**INDEPENDENT ADVISORY
PANEL FOR UNDERGROUND
MINING**

**MOOLARBEN COAL COMPLEX
UG4**

**LONGWALLS 401-408
EXTRACTION PLAN**

April 2022

Figure 3: Site S1MC280 position, relative to longwalls 402 and 403 (direction of longwall retreat is from right to left)

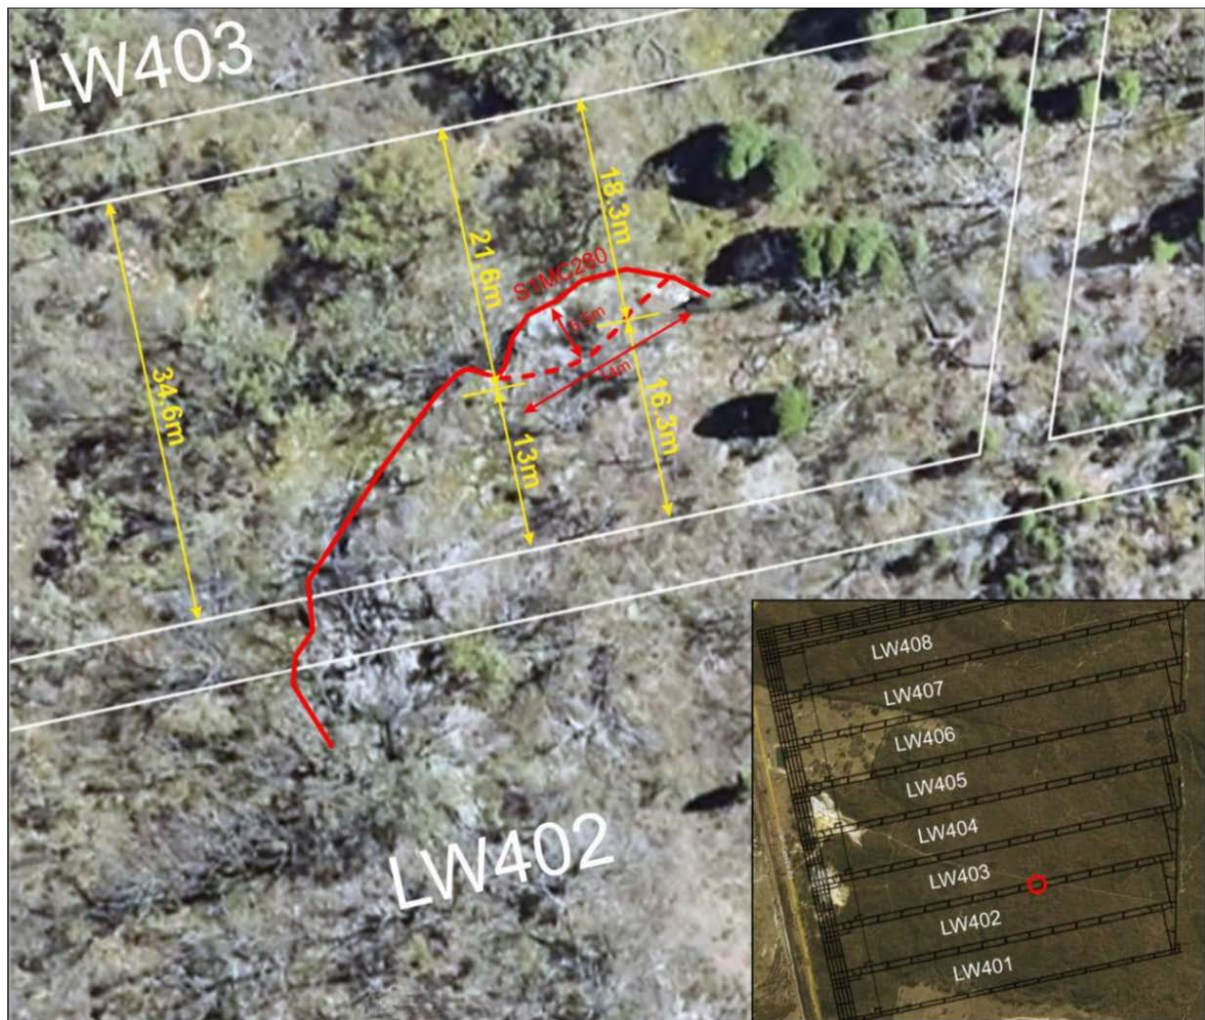
The response to this request (22 March 2022) indicates a tilt of 5.0mm/m (presumably towards LW402, or into the hillside behind the rock shelter), as 402 passes. The resultant tilt after 403 then passes the site is then predicted to be 4mm/m (presumably in the opposite direction, or down-slope towards 403). The sense of these tilt values is yet to be confirmed by the Applicant/MSEC, but if this interpretation is correct, it would suggest an incremental rotation of the rock shelter of up to 9mm/m towards the down-slope direction, between the passing of 402, and when 403 has passed. Based on a plan provided by the Applicant (11.04.22), the maximum depth of the rock shelter overhang is approaching 6m+. This would result in a net incremental rotation of up to 54mm.

The Panel has serious concerns about the ability of the rock shelter overhang to withstand these levels of incremental tilt, especially when combined with some degree of potential cracking and/or shearing. The Panel therefore recommends that the Applicant should develop a mining plan, as part of the overall mitigation strategy for the site, to create a reduction in the panel

width of LW403 in the region where it passes Site S1MC280, to avoid any adverse tilt or strain impacts (beyond restoring the shelter to its original tilt configuration) as this panel passes in front of the shelter.

- a) The Applicant should identify and design a suitable “early warning” subsidence monitoring site above the 402/403 row of chain pillars, at least several pillars inbye of Site S1MC280, to monitor the subsidence effects and impacts of both LW402 and 403, ahead of reaching Site S1MC280, to determine the actual subsidence, tilt and strain figures, by comparison to the predicted values.

- b) Establish a comprehensive TARP for both the “early warning” site listed in (a) above, and for monitoring at the rock shelter.
- c) Provide a comprehensive mitigation plan for the site, to cover all actions to prevent any significant cracking or instability of the shelter due to subsidence, tilt or strain. This should include the planned stress-relief slotting design; consideration of temporary support of the overhang; and design of a LW403 Panel face shortening, to leave some additional coal in the vicinity of the site. This mitigation plan should also be linked to the above TARPs.

Figure 4: Surface geology and known structures

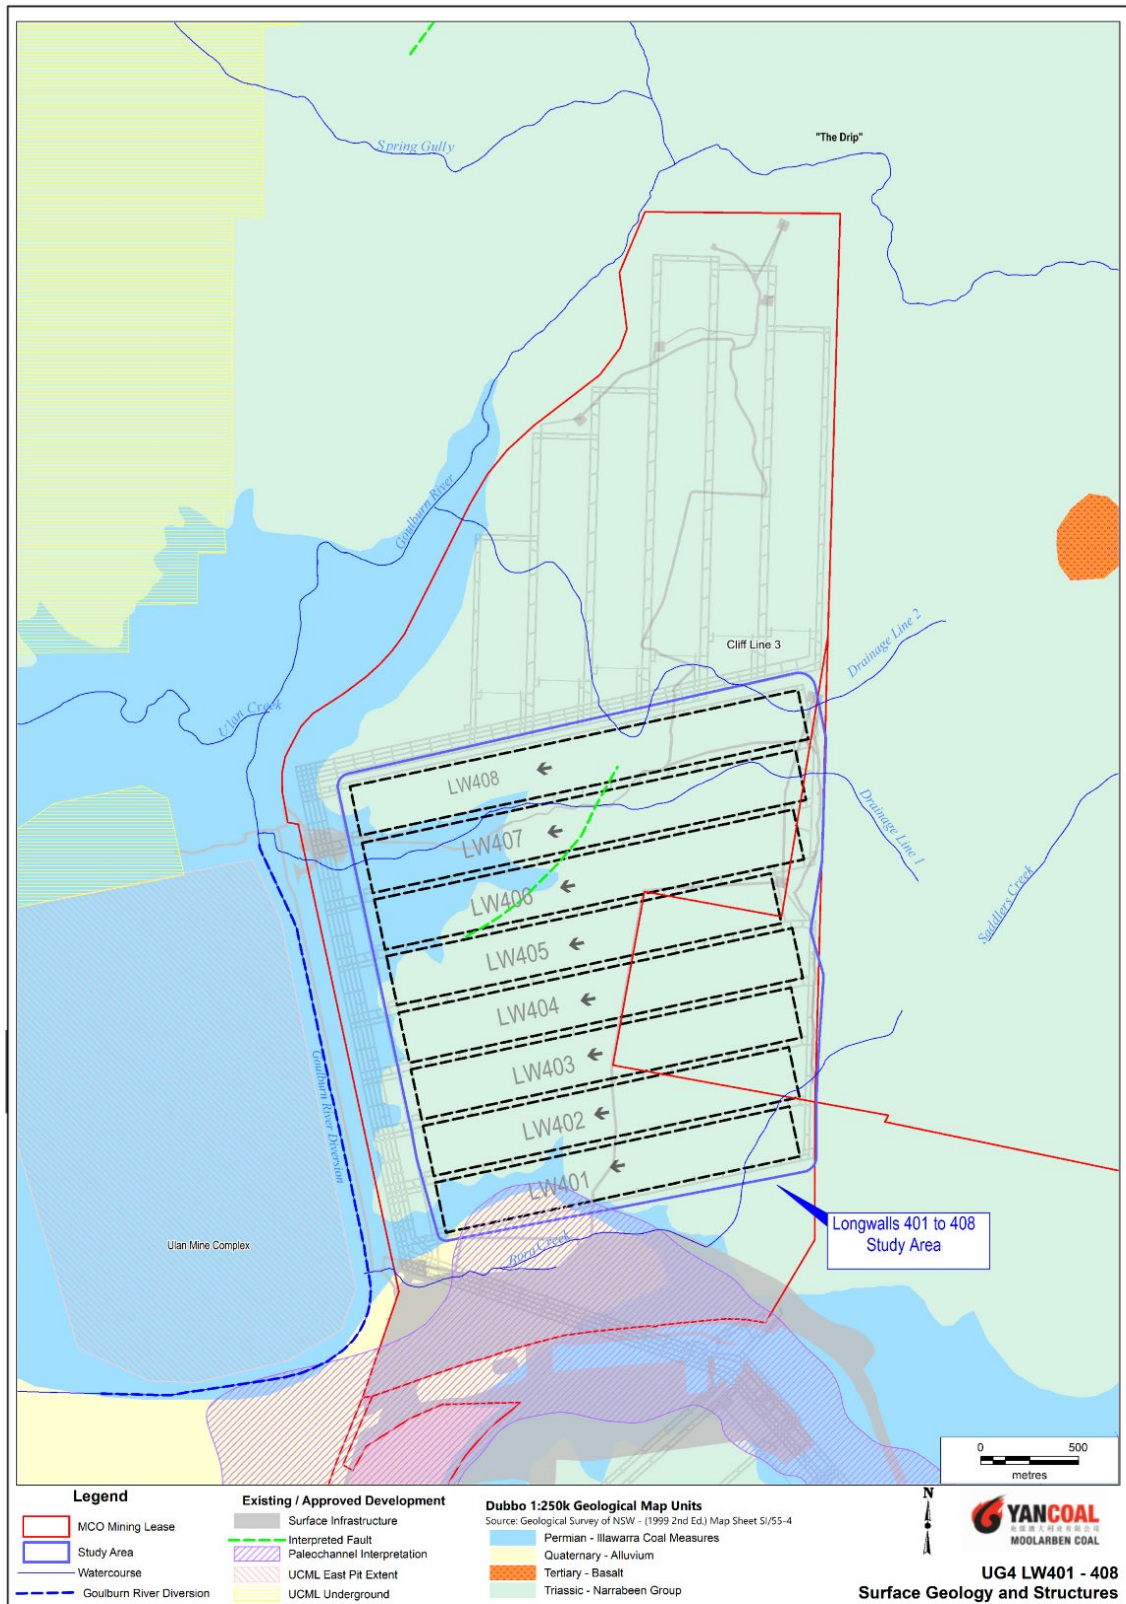
The surficial extent of these geologies is shown on Figure 4. While the mapped geology is well known there is minimal detail regarding structural features (such faults, fractures, and lineaments) across the UG4 area and adjacent areas. The only mapped and identified feature to date is an inferred fault extending from the south-western portion of LW406 through to the

central portion of LW408 and trending in a north-easterly direction (see Figure 4). Such features can enhance or restrict groundwater migration and flow.

- A geological structural analysis be completed as soon as practicable to determine whether there are any natural defects in the geology that could enhance or restrict groundwater migration and flow, and necessitate expanded monitoring and/or updated modelling

- An interim report on the geological structure and potential implications for groundwater impacts be supplied to the Department no later than 30 June 2022. Based on this report the Panel may provide further advice on additional groundwater monitoring or the siting of proposed monitoring bores (see Section 4.3.3)

Figure 6: Triassic sandstone saturated extent and groundwater contours (2011)

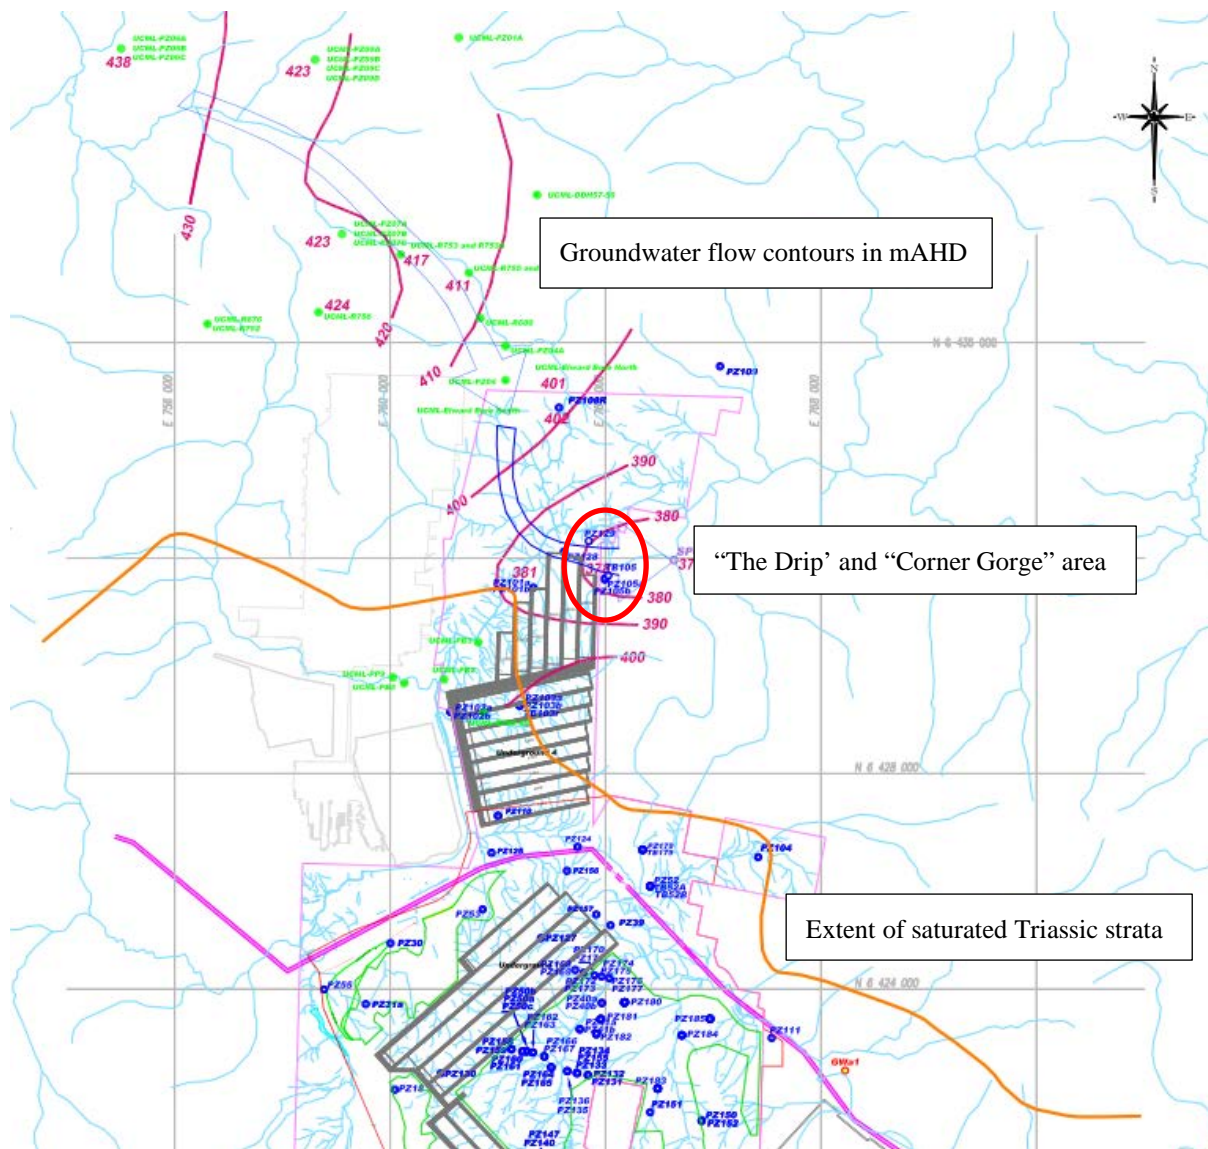
There is a lack of data in the vicinity of LW401 to 408 to properly define the saturated extent of Triassic sandstone and the current groundwater flow contours. Based on limited 2011 site data, Figure 6 (reproduced from RPS Aquaterra 2011) shows the extent of saturated Triassic strata and the groundwater level contours for the sandstone aquifer at that time.

"The Drip" and "Corner Gorge" locations are clearly within the groundwater discharge area of the Triassic sandstones to the Goulburn River. Groundwater sustaining the "The Drip" on the northern cliff face above the Goulburn River (as shown in Figure 7) is from groundwater migrating from the upper Triassic sandstone aquifers north to south. There are different discharge horizons evident in the cliff face however there is no regional evidence to confirm the Triassic sandstone aquifers are perched in relation to the underlying Permian ICM groundwater system.

The Panel's assessment is that the current Extraction Plan for LW401 to 408 is extremely unlikely to impact the water supply at "The Drip". However it is also the Panel's opinion that there is no current evidence to support the statement (AGE 2021) that:

Figure 8: Triassic sandstone aquifer water levels to January 2021

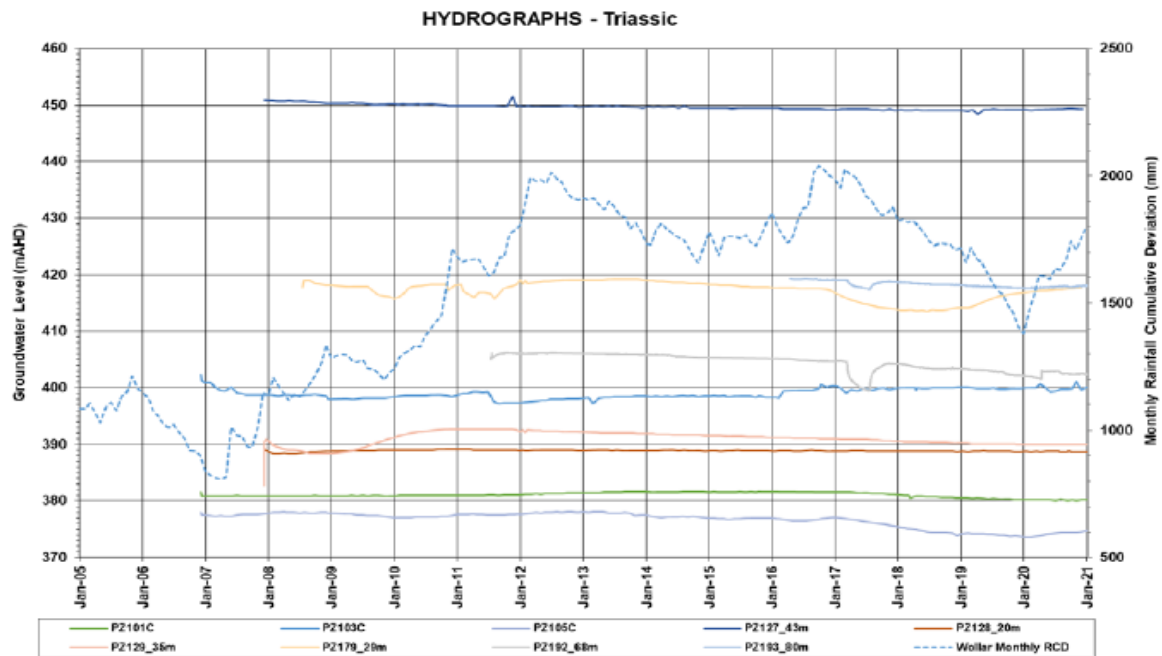
Based on the hydrographs presented in the 2020 AEMR (Yancoal 2021c) (see Figure 8), mostly seasonal variations in water levels are evident in the Triassic sandstone aquifers in the vicinity of LW401 to 408 and towards “The Drip”. The small declines in Triassic sandstone water levels at PZ192 and PZ193 in 2017 are the result of dewatering trials when 50ML of groundwater was pumped from MPB103.

Figure 9: Permian aquifer water levels at selected sites to January 2022

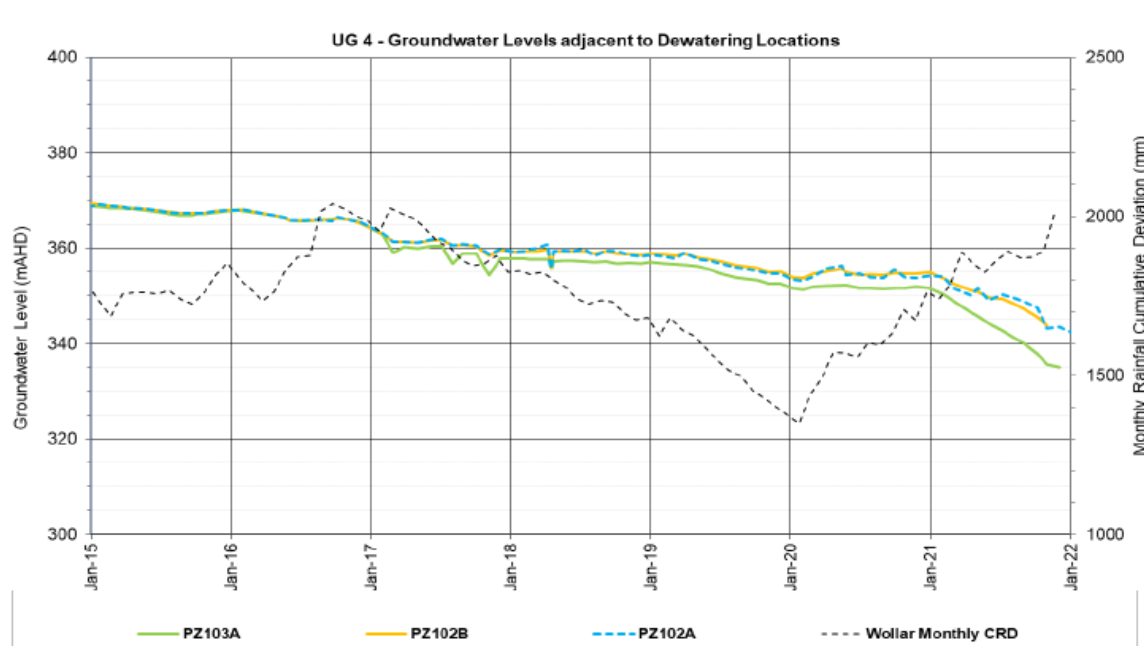
There is also insufficient site data to produce Permian overburden and Permian Ulan Seam water level contours for the UG4 area and to confirm flow directions and connectivity with the overlying Triassic sandstone aquifer. The recently supplied hydrograph (from Yancoal 2022) showing 15-20m declines in water levels in the deep Permian aquifers during 2021 at the PZ102 and PZ103 sites (Figure 9) is concerning. These two sites are located above and adjacent to LW407 and LW408 and emphasise the need for additional nested monitoring sites prior to the commencement of mining in the UG4 area. It is unclear whether these recent trends are Moolarben Coal Complex (MCC) or Ulan Coal Complex (UCC) related.

The Panel accepts that the coal measures are depressurised across the MCC due to historic and current mining activities resulting in regional water level declines in the ICM groundwater system. As a result of hydraulic connection and the height of fracturing above the proposed longwalls, groundwater will also drain vertically from the overlying Triassic sandstone aquifer (AGE 2021).

Figure 10.: Drainage lines, surface water monitoring locations and layout of proposed longwalls in UG4 (Figure 4 of Yancoal 2021d)

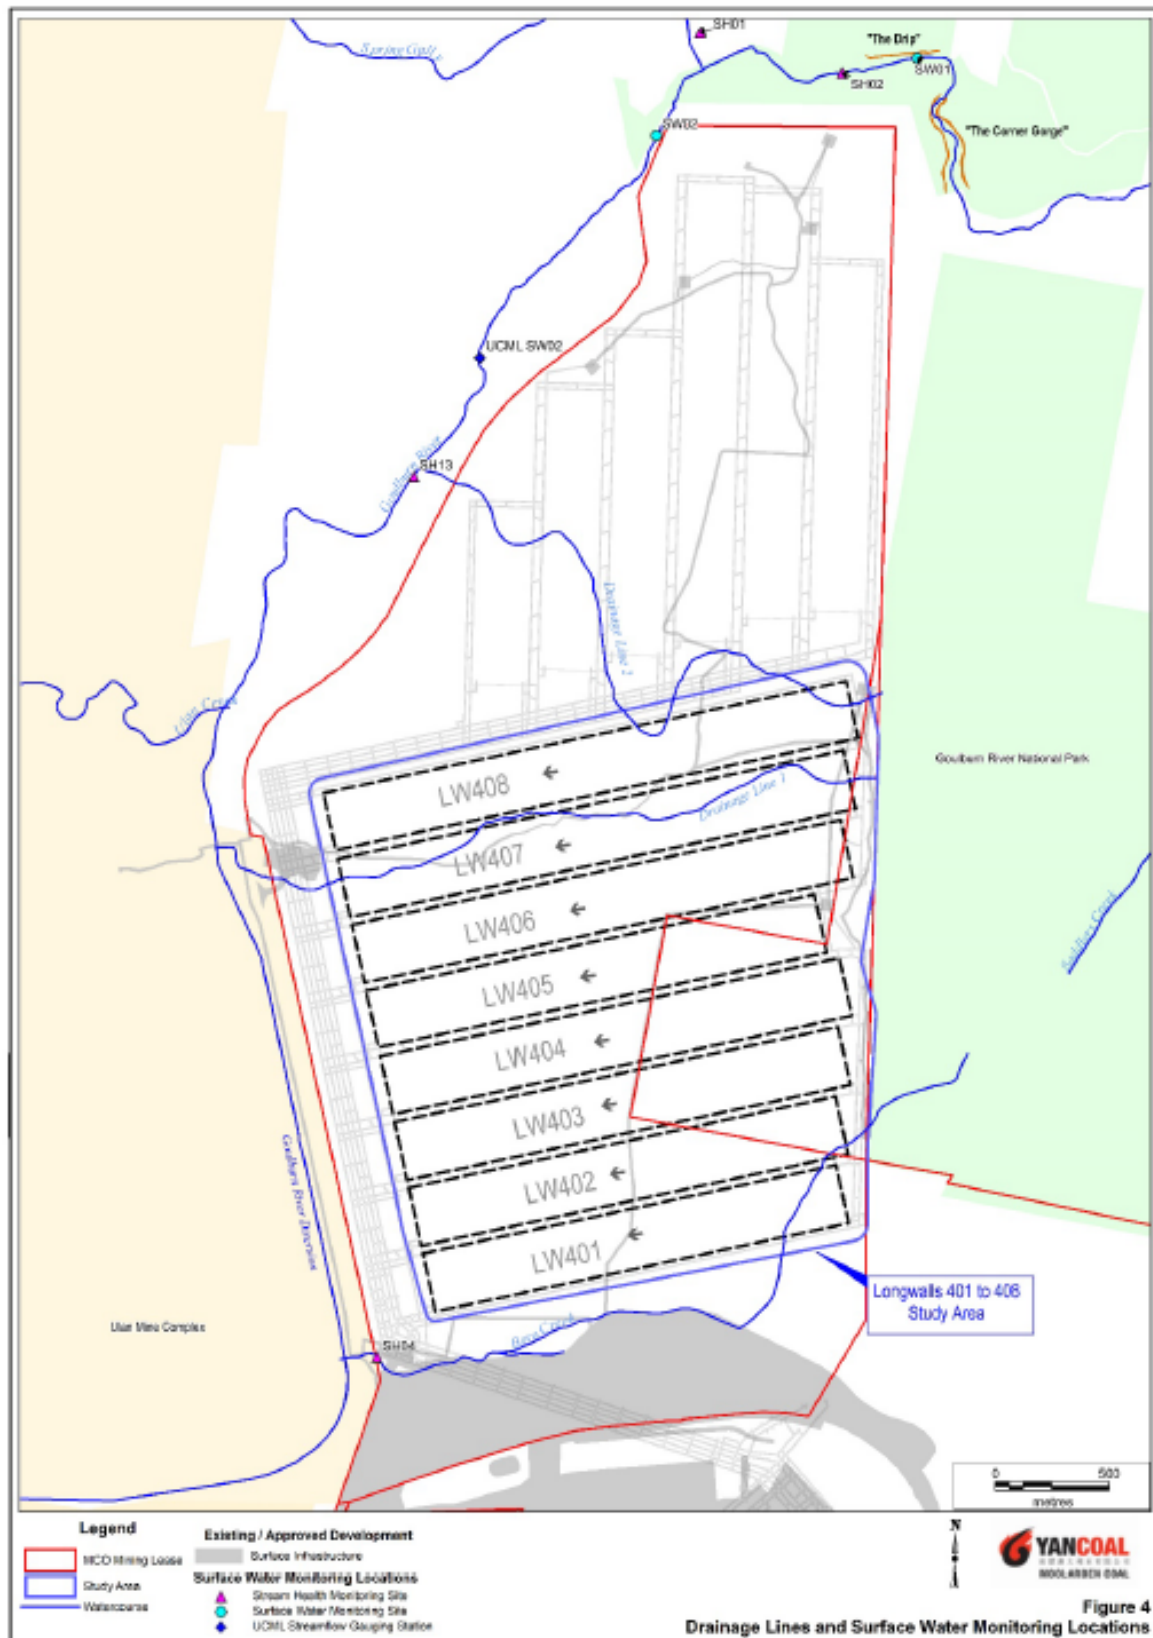
Figure 10 below shows the UG4 mining area, drainage lines and surface water monitoring sites. The identified low-order watercourses affected by LWs 401-408 are Bora Creek and Drainage Lines 1 and 2 (Figure 10). The regionally significant affected watercourse is the Goulburn River.

Adequate monitoring plans are in place for impacts to Bora Creek. With regard to the planned baseline channel stability monitoring of Drainage Line 1 (see Table 1), it is possible that impacts will occur during the mining of LW406. Therefore, the Panel recommends that the baseline for Drainage Line 1 should be undertaken prior to commencement of LW406. Similarly, the baseline for Bora Creek should be undertaken prior to commencement of LW401.

For Drainage Lines 1 and 2, considerable effort is planned for baseline and impact monitoring but no TARPs are in place. TARPs should be proposed for water quality, with the purpose of identifying and managing significant adverse impacts on water quality of discharges to the Goulburn River.
